Addendum No. 1
Rock River Water Reclamation District
Plant Roadway Improvements 2020
Capital Project No. 2106

This Addendum No. 1, dated August 13, 2020, for the above referenced project, supersedes all contrary and conflicting information in the specifications and contract documents, which are hereby supplemented or revised as follows:

PLANT ROADWAY IMPROVEMENTS 2020 CAPITAL PROJECT #2106

TYPICAL SECTIONS ALIGNMENT G -1

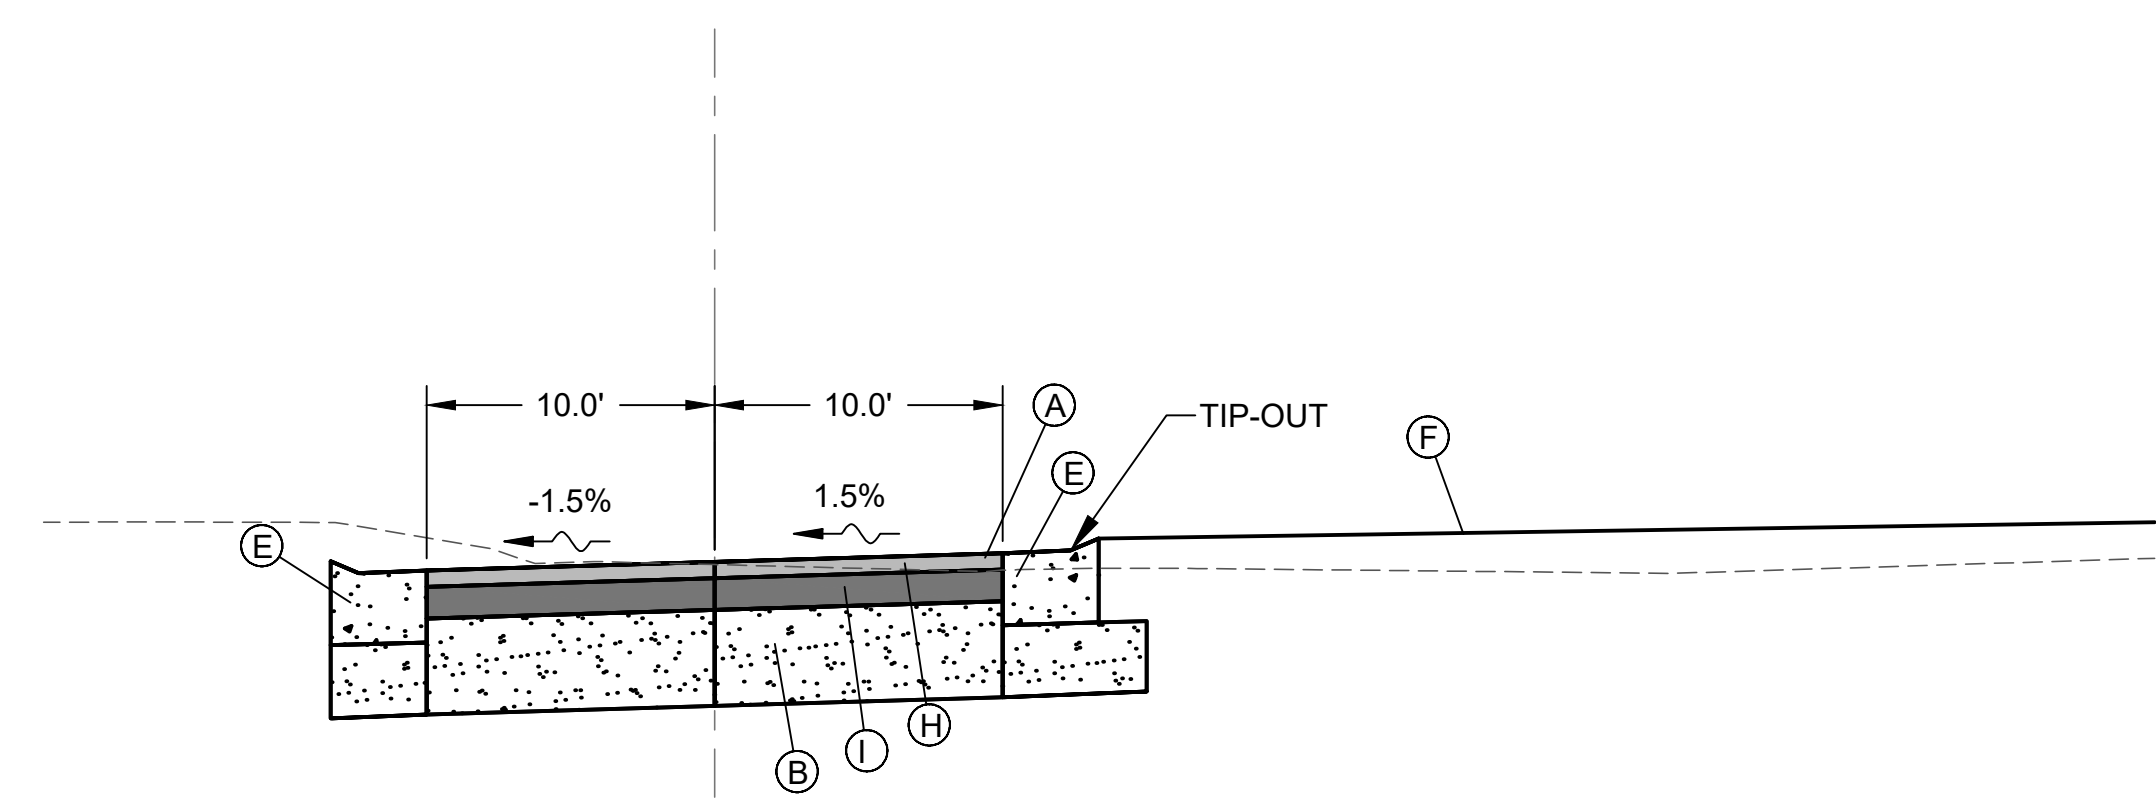
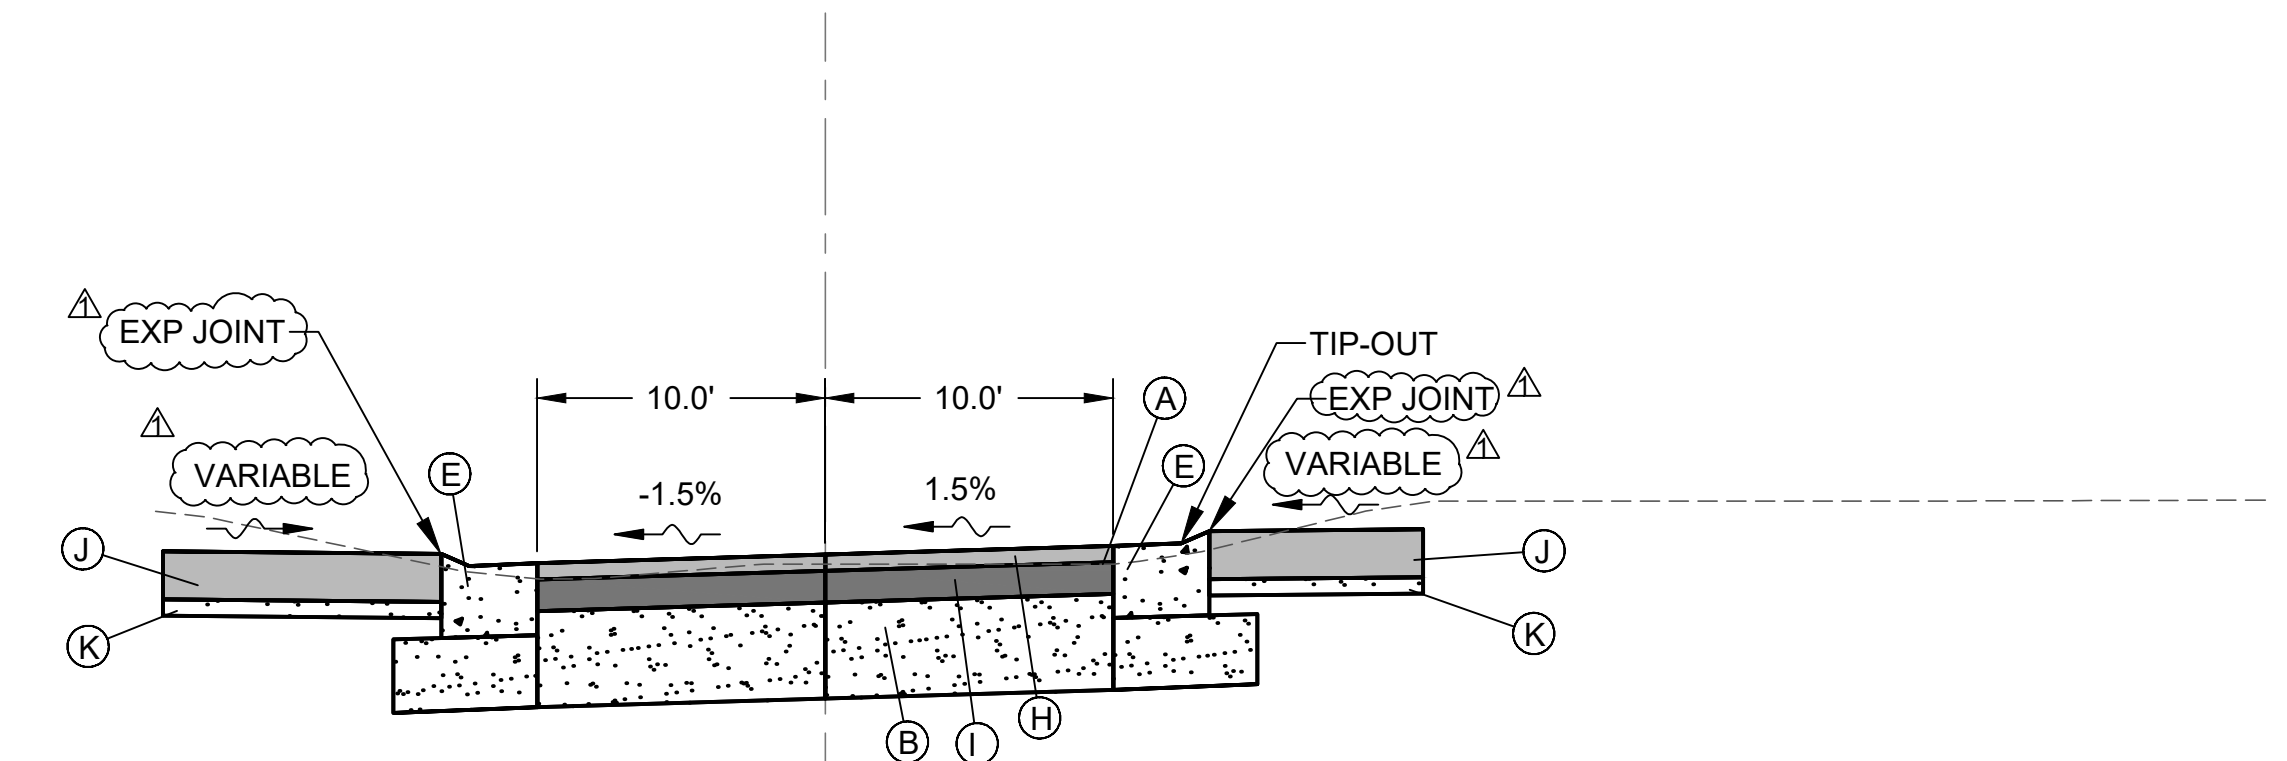
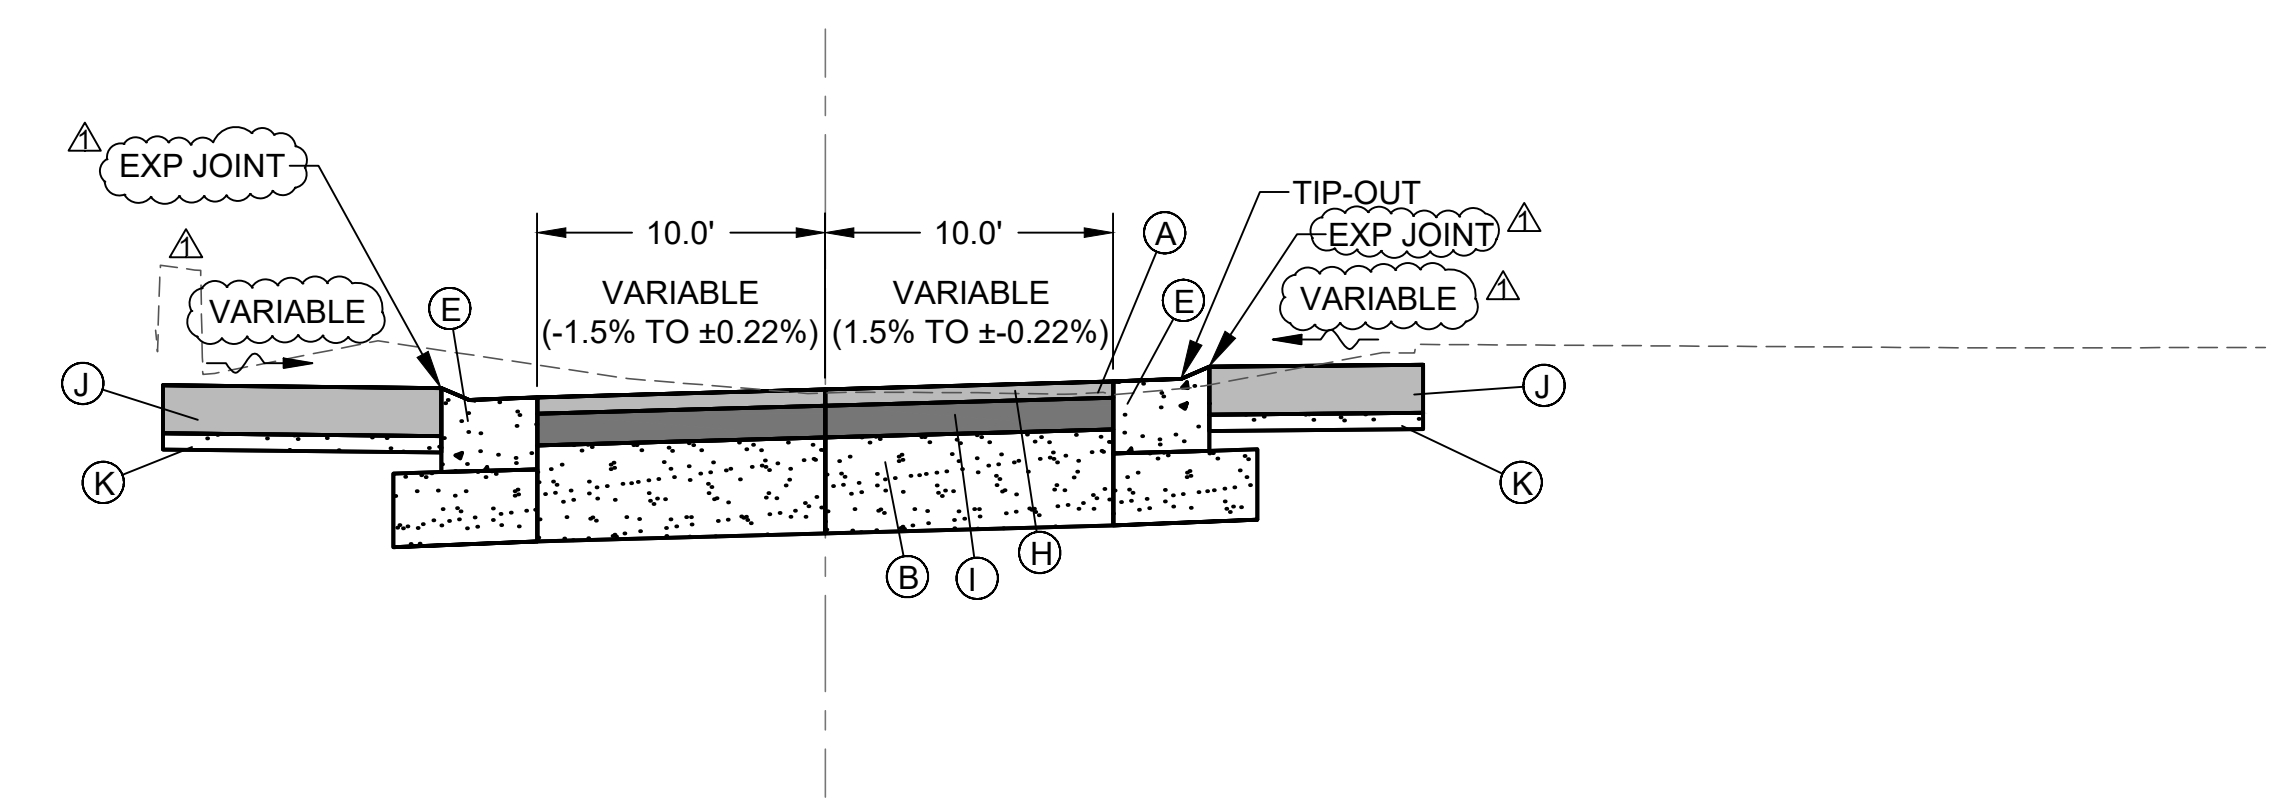
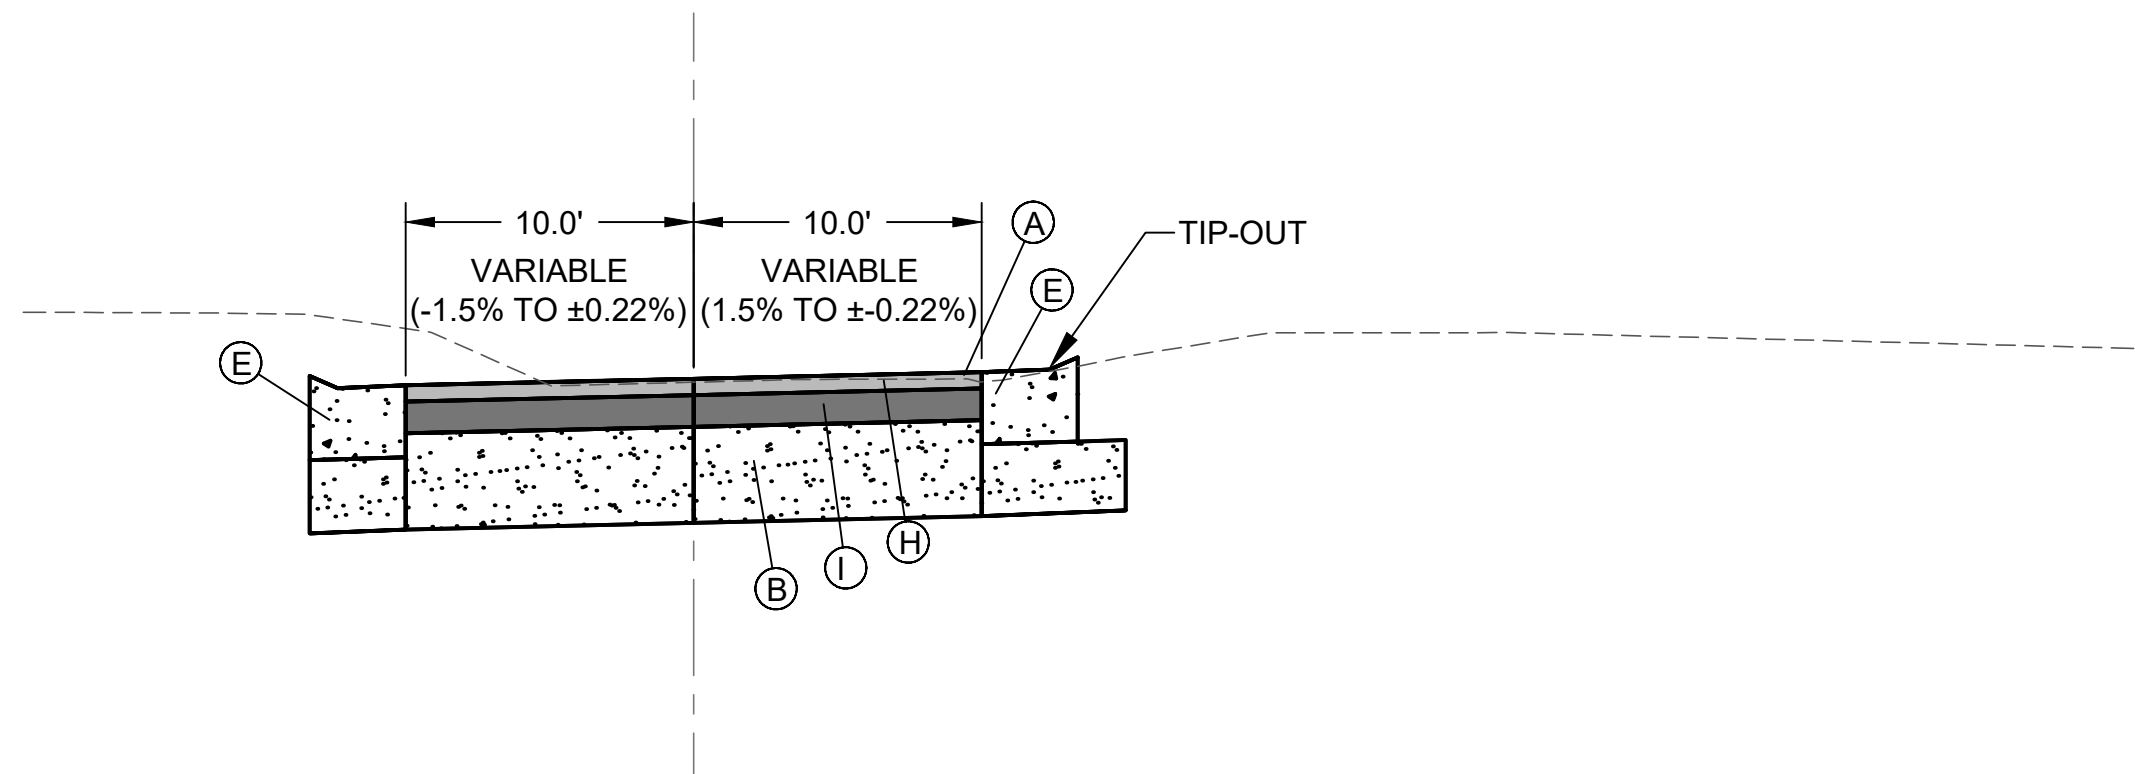
1. Typical Sections have been updated to reflect the addition of expansion joint and to note that the proposed PORTLAND CEMENT CONCRETE SIDEWALK, 6" will have a variable slope.

TYPICAL SECTIONS ALIGNMENT G -2

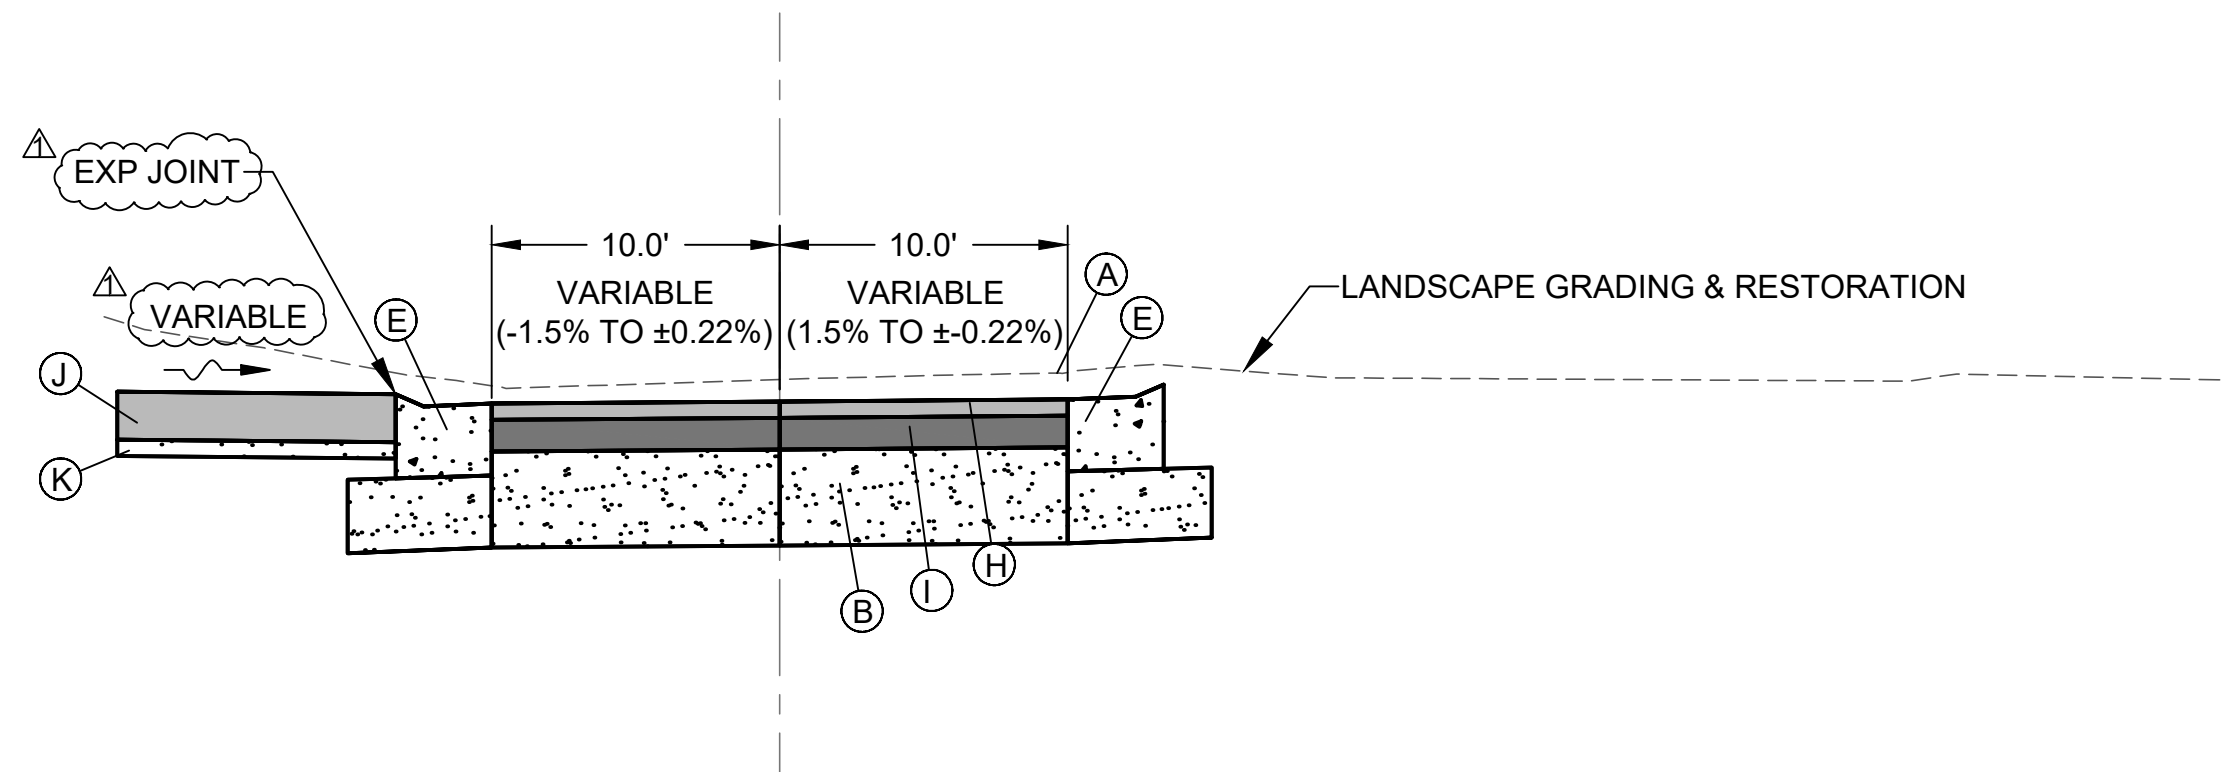
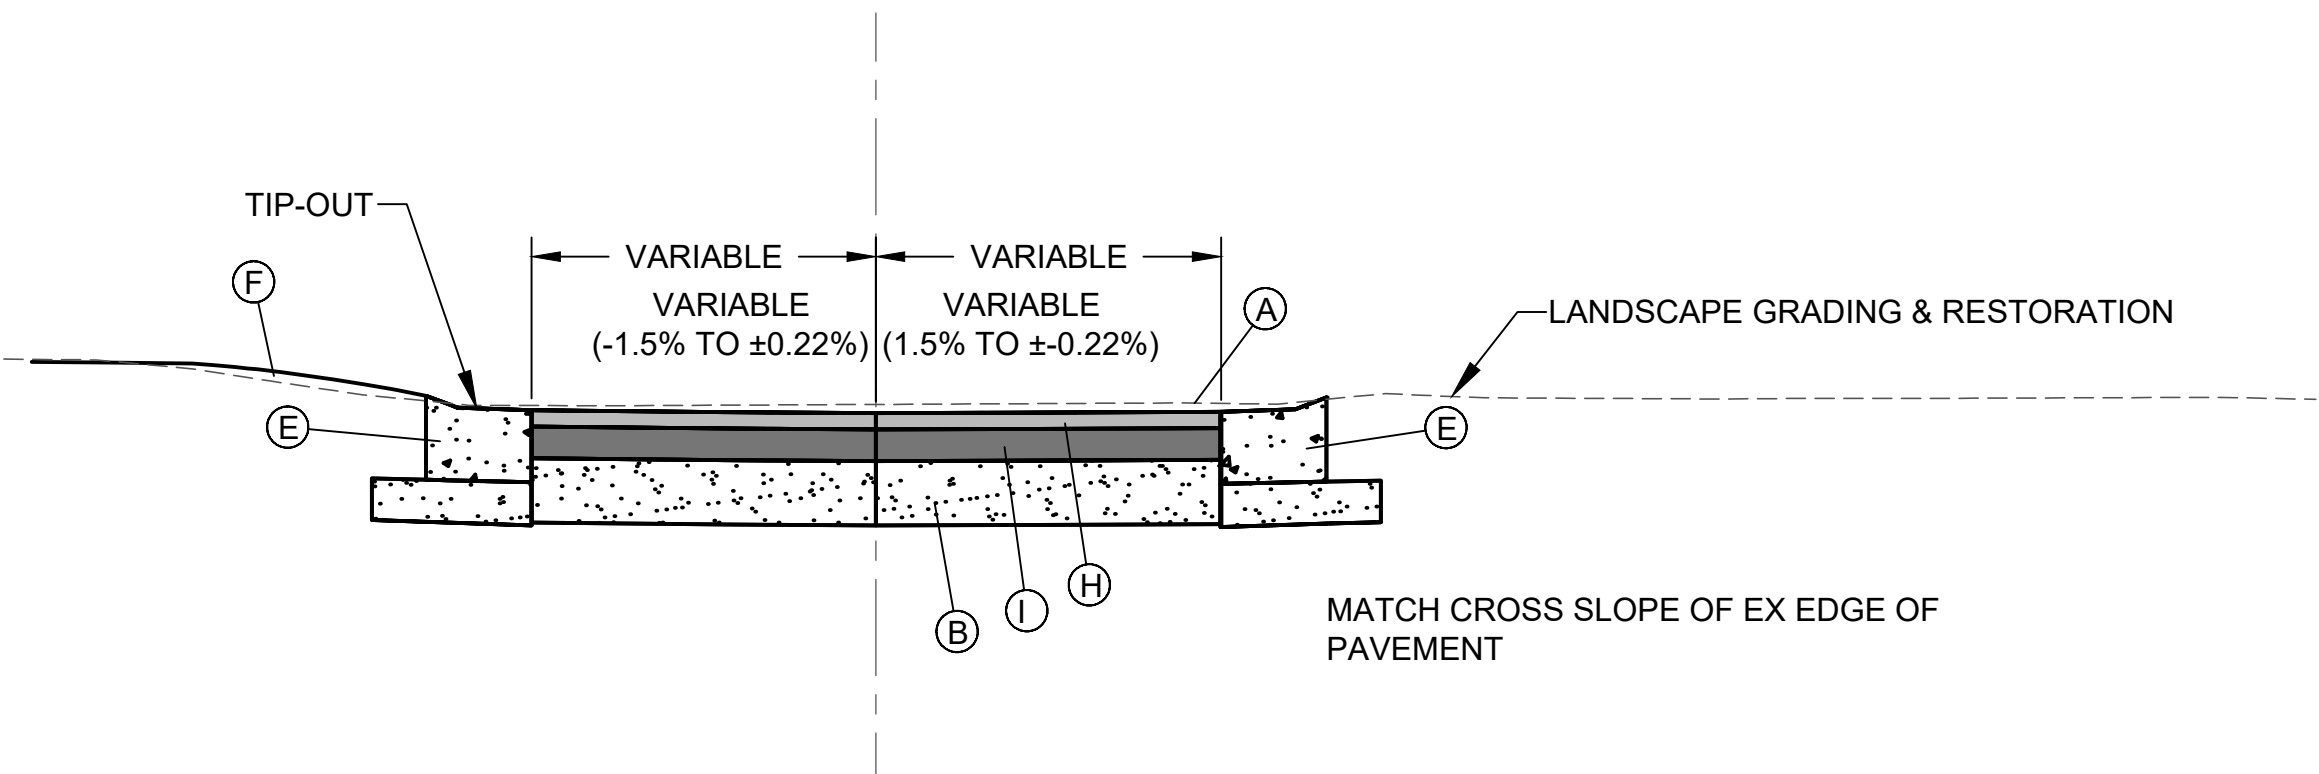
1. Typical Sections have been updated to reflect the addition of expansion joint and to note that the proposed PORTLAND CEMENT CONCRETE SIDEWALK, 6" will have a variable slope.
